THE PORT AUTHORITY OF NY & NJ

ADDENDUM #6

**TO PROSPECTIVE BIDDER(S) ON CONTRACT # WTCR – W30-2011-31
WTC REDEVELOPMENT – WTC TOWER 2 PLAZA INTERIM IMPROVEMENTS**

SK-2A
SCALE: 1" = 1'-0"
MPFP
2-10-15

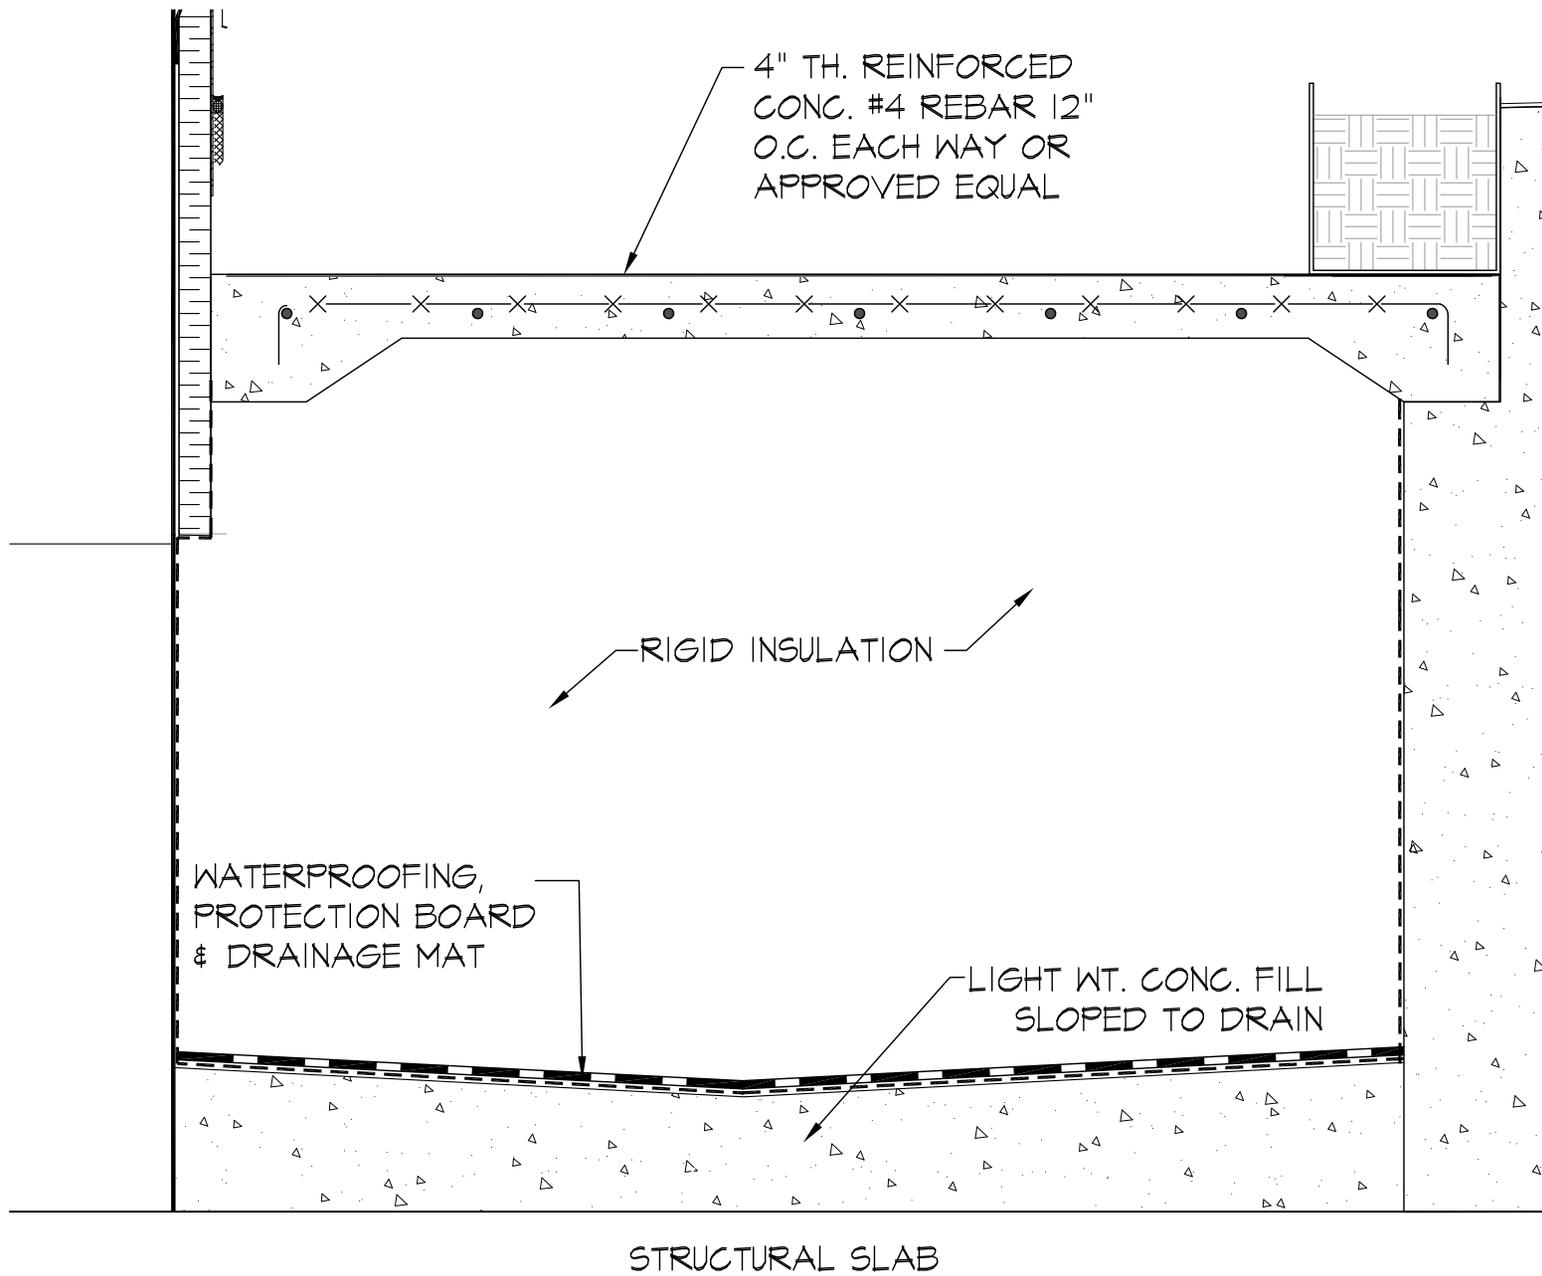
Question #150	Addendum No 2, SK-2A, shows “ 4” TH. REINFORCED CONC. #4 REBAR 12” O.C. EACH WAY OR APPROVED EQUAL.” It is supported on the right side (East) by what we interpret to be the plinth shown on S-300; but there is not visible support on the left side (WEST) except for the “RIGID INSULATION.” Is that the intent?

Answer # 161	Section 01810 is not applicable and shall be ignored.
Question #162	As per SK-2 (dated 2-10-15), detail on SK-2A (dated 2-10-15) applies at the entire area behind the Green & Stone walls. Shouldn't this detail apply only at areas of the depressed slab as identified on SK-7 (dated 2-10-15)?

Answer #150	Any areas of new raised slab on Styrofoam shall follow the typical raised slab construction detail shown in SK-16 for the purpose of slab thickness, knee wall sizes and rebar requirements.

Answer # 162	SK-7, SK-8, and SK-9 are sketches that are intended to reflect the existing conditions that are required to be demolished. Contractor shall assume SK-2A applies where cross-referenced from SK-2.

SK-4
 SCALE: 3" = 1'-0"
 MPFP
 2-10-15

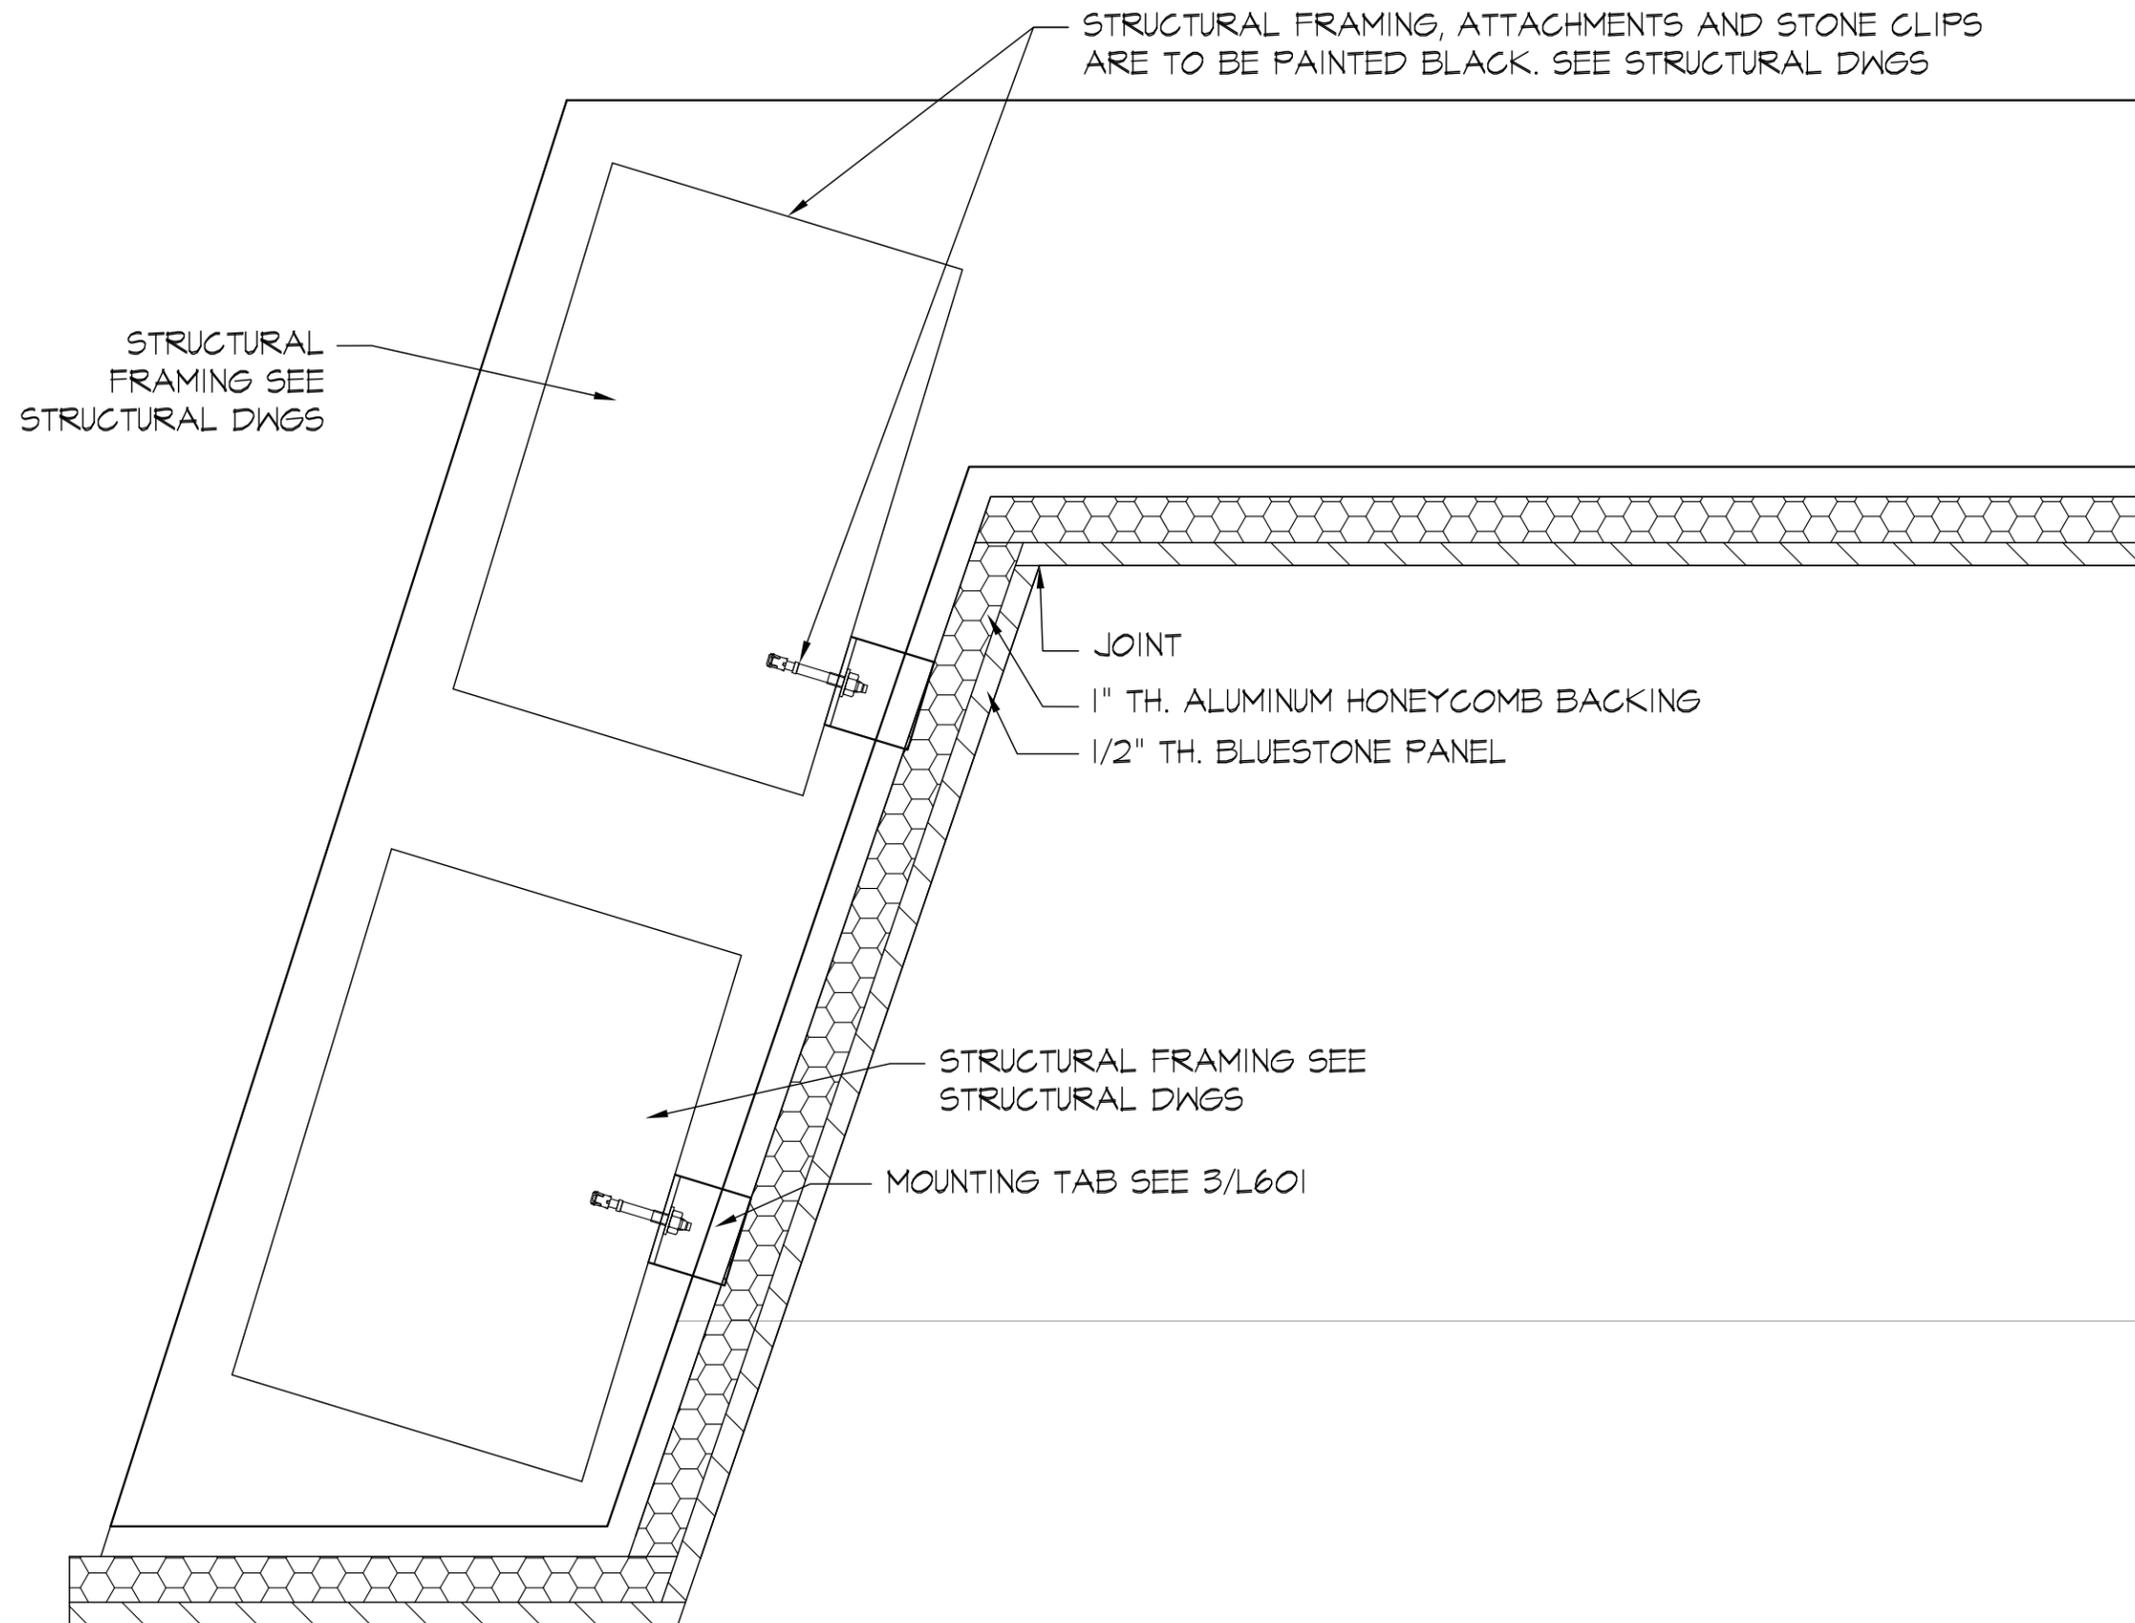
Question #153	Addendum No 2, SK-4 shows the ½” BLUESTONE PANEL” on the “ 1 ½” HONEYCOMB BACKING”. The panels follow the indentation of the Structural Frame, however the panels continue a short distance parallel to the North South Structural Frame Axis. Please provide more information on the geometry and the mounting of this portion of the stone panel.

Question #159	Sketch SK-4 (attached) plan detail doesn't show any vertical joint locations. We need to divide this into 3 separate panels to set. Please advise.

Answer # 153	All panels are to be mounted as shown. Detail is typical of all locations throughout.
Question #154	Drawing L-101 at the lower left corner and upper left corner of the Plaza shows the “pavers” in a markedly different legend than “ 4” x 4” PAVERS” or “ 8“ x 4” PAVER BAND” What is the pattern at these tow corners?

Answer # 159	Contractor to assume a maximum of 2 vertical joints.
Question #160	Addendum 2, Question and Answer #32- Paint the back of the panels black. Please provide a specification to the paint to be used for this application.

Tower 2 Plaza Interim Improvements
SK-7
2/10/2015

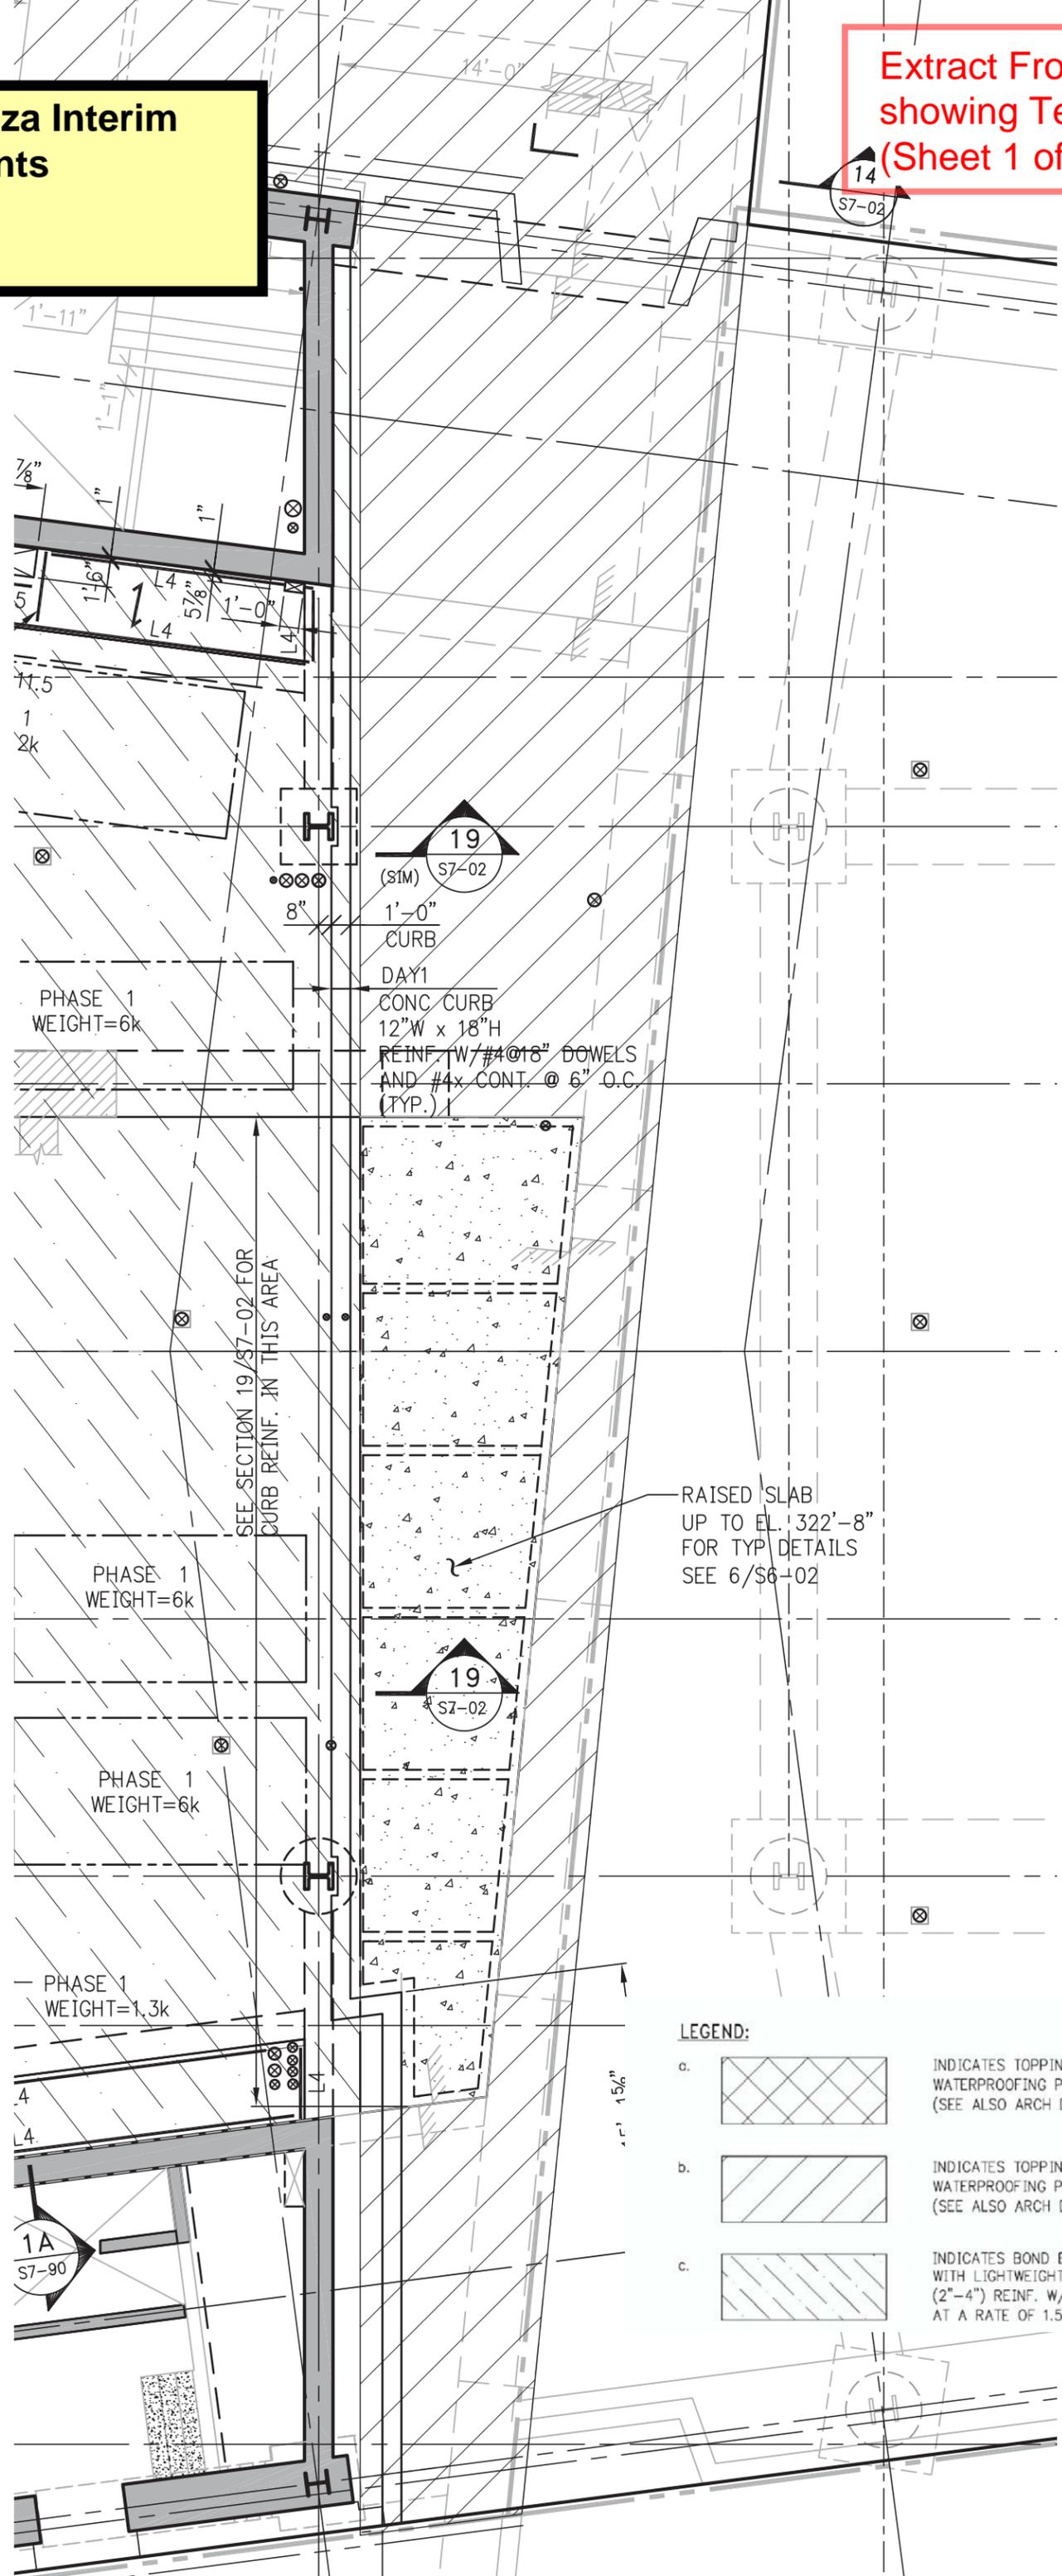
Question #143	<p>SK-7 is entitled “Extract from Floor Plan showing Temp Slab Build up (Sheet 1 of 3)”.</p> <p>1. It shows a callout on the right hand side saying “RAISED SLAB UP TO EL. 322’-8” FOR TYP DETAILS SEE 6/S6-02” Is this an existing built up slab to be demolished? If so, how high is it above the floor slab? How thick is it” How many supporting ‘walls are there” Is there a supporting wall adjacent to the building wall? Is there a supporting wall adjacent to the slurry wall?</p> <p>2. It shows three (3) LEGEND symbols. The first a. says “INDICATES TOPPING SLAB AND WATERPROOFING PER DETAIL 1/ S7-90 (SEE ALSO ARCH DWGS)”. Who cares because there is no Cross-Hatching symbol on SK-7. The second b. says “INDICATES TOPPING SLAB AND WATERPROOFING PER DETAIL 5/S7-90 (SEE ALSO ARCH DWGS)”. We do not have 5/S7-90 so please tell us how thick is the topping slab. The third legend c. says “INDICATES BOND BREAKER...”; and who cares because it is all shown as inside the building. We are not going inside the building, are we? So, bottom line, we have no useful information about the demolition between the slurry wall and the building.</p> <p>3. The answer also says “For all other areas the Contractor is to assume existing 6” layer of crushed stone and soil.” Referring to Drawing S-100.00 at “5 GROUND FLOOR PLAN”, the South end of the bench plinth extends beyond the slurry wall. Will the crushed stone and soil support the bench plinth. Please advise.</p>

Question #148	Addendum No 2, SK-7. (Sheet 1 of 3), shows a plan view of what is described on the right hand side of it as a “RAISED SLAB UP TO ELEV 322’-8” FOR DETAILS SEE 6/S6-02” There is a section shown thereon as 19/S7-02. When we refer to 19/S7-02 on SK-8 (Sheet 2 of 3) it shows several inconsistencies. A. For the slab it says on the bottom right “SEE PLAN” Is this the existing slab? B. It says just above that “FINISHES”. What is meant by “FINISHES” C. It says near the top right “SEE ARCH FOR RAISED SLAB EL.” Drawing A.03.101 shows no information about the elevation of the raised slab and it is completely out of whack with any sections on Drawing S-300. Please clarify. D. at the top of what looks like a reinforced concrete wall 12” thick it says “EL. VARIES SEE ARCH”. What “ARCH” shows this? E. To the right of this “wall” shows dotted lines. What are the dotted lines?

Question #149	Addendum No 2, SK-7 (Sheet 1 of 3), within the “RAISED SLAB” shows what looks to be 6 ‘cells’, What do the dotted lines represent?
Answer #149	SK-7 indicates the current as built condition adjacent to the Tower 2 structure, for the purposes of defining demolition scope. The Raised slab, stair, knee walls, and built-up assembly shall all be demolished down to the existing structural slab. The 12" foundation wall shall remain. For further details of this construction, see sketch SK-9 in Addendum 2.

Question #152	Addendum No 2, SK-7 (Sheet 1 of 3), within the “RAISED SLAB” shows a section 19/S7-02. To the North of the Raised Slab area shows a section SIM 19/S7-02. How is it similar if there is no raised slab? What does it represent?

Answer # 143	<p>1 and 2: SK-7 indicates the as built condition in this area. The raised slab consists of concrete slab on concrete knee walls with Styrofoam infill. The dashed lines indicate the approximate locations of the concrete knee walls. Raised slab, concrete knee walls, and styrofoam infill build-up shall be demolished down to Structural slab. For further details of this construction, see Sketch SK-9 in Addendum 2. The existing elevation of the structural slab is 322'-8" (steps down to 322'-4" at the North). Also refer to SK-15. No demolition required inside the building.</p> <p>3. Adopt detail 4/S-300 where bench plinth extends beyond the slurry wall, with the exception that there will be no requirement for any dowels.</p>

Answer #148	SK-7 indicates the current as built condition adjacent to the Tower 2 structure, for the purposes of defining demolition scope. The Raised slab, stair, knee walls and built-up assembly shall all be demolished down to the existing structural slab. The 12" foundation wall shall remain. For further details of this construction see Sketch SK-9 in Addendum 2.

Answer #152	The similarity is the 12" existing foundation wall to remain. The interpretation that there is no raised slab at Section SIM 19/S7-02 is correct.
